SUBJECT: MEETING NOTES OF JULY 27 THROUGH 30, 1982 DESIGN AUDIT

Plant Name: Midland Plant, Units 1 and 2
Licensing Stage: OL
Responsible Branch: LB #4; D. Hood, and R. Hernan, LPM

MEETING NOTES NO. 1655

SUBJECT: Nuclear Regulatory Commission Audit of Soils Remedial
Activities

SETTLEMENT MONITORING MATRIX

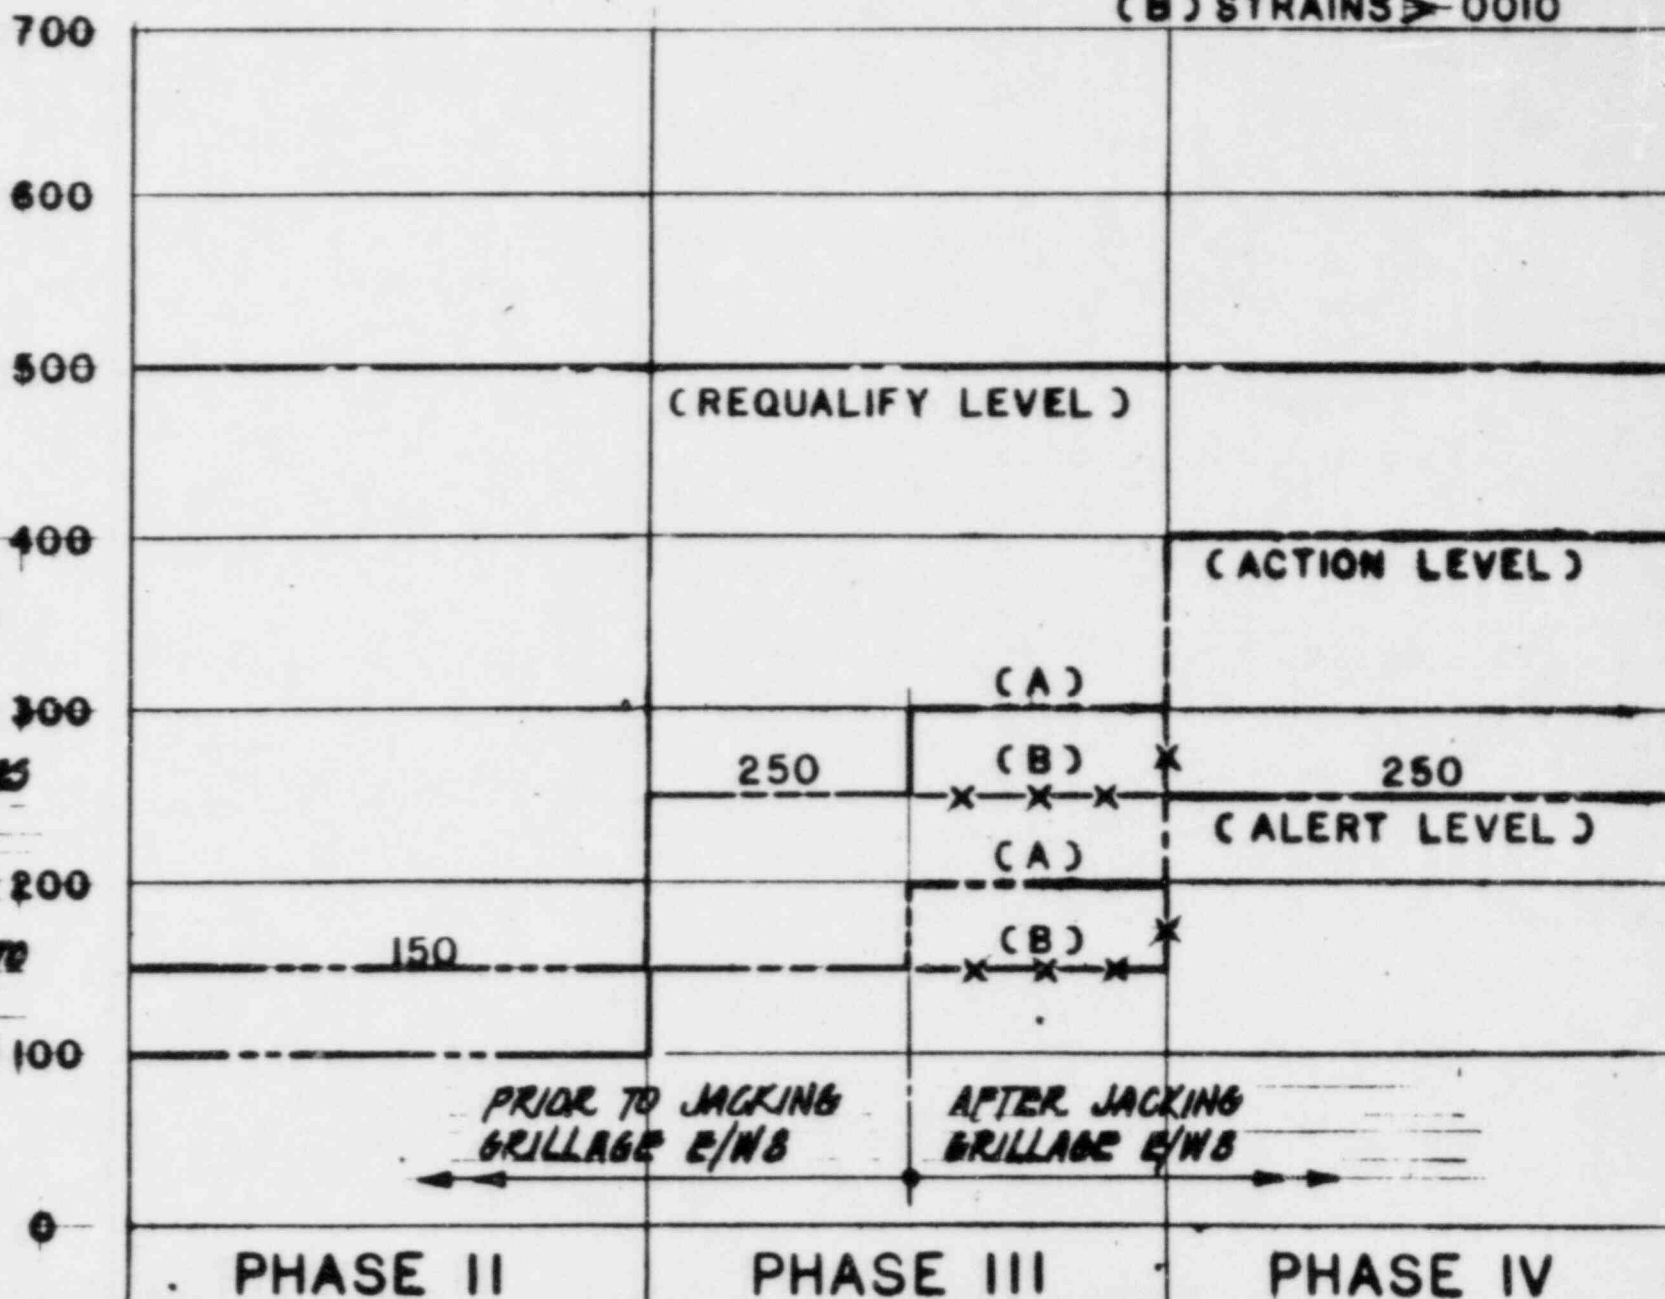
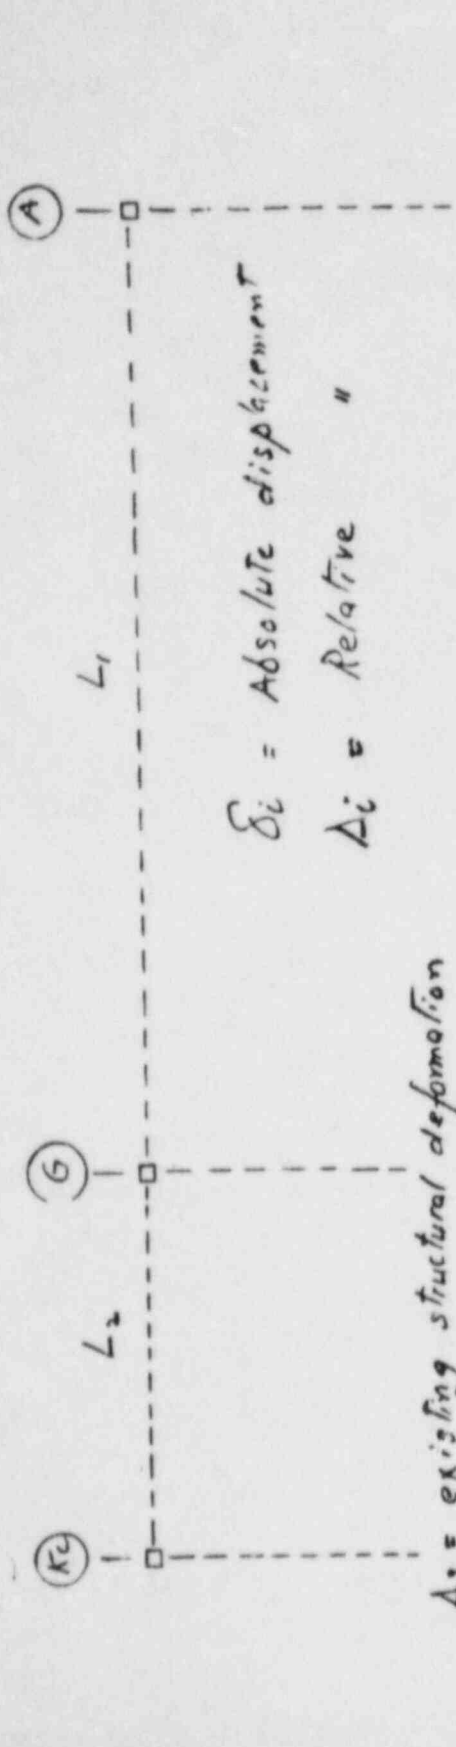
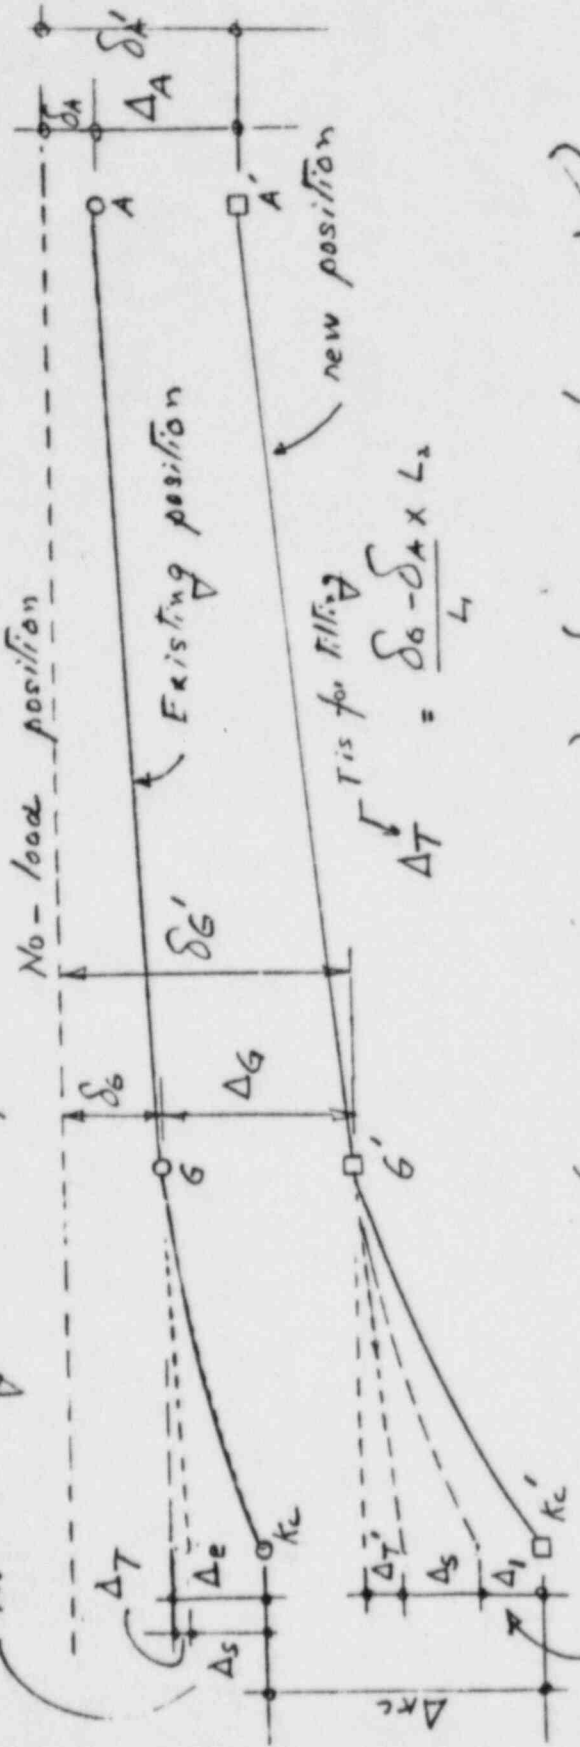
and strain levels greater than 0.0010 in/in. are a factor to be considered in the raising of the alert and action settlement levels.

PLAN OF BURIED PIPE LOCATION

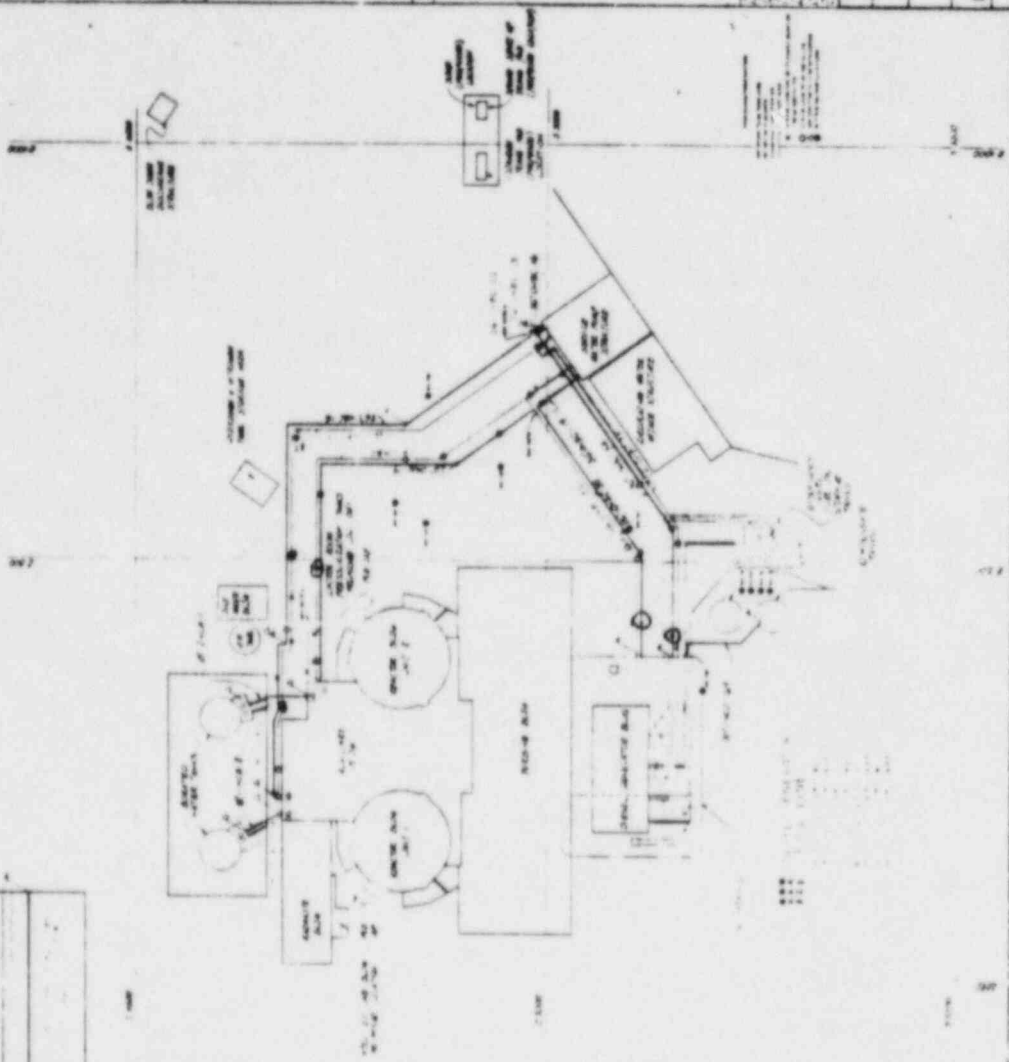
Attachment 4 is a reduced drawing that is not clear and does not permit checking whether agreed upon locations were added.

The five additional settlement and strain marker locations are station 1+52 and 3+15 for line 26" OHBC-15, station 1+55 for line 26" OHBC-20, station 0+80 for line 26" OHBC-55 and station 3+00 for line 26" OHBC-54.
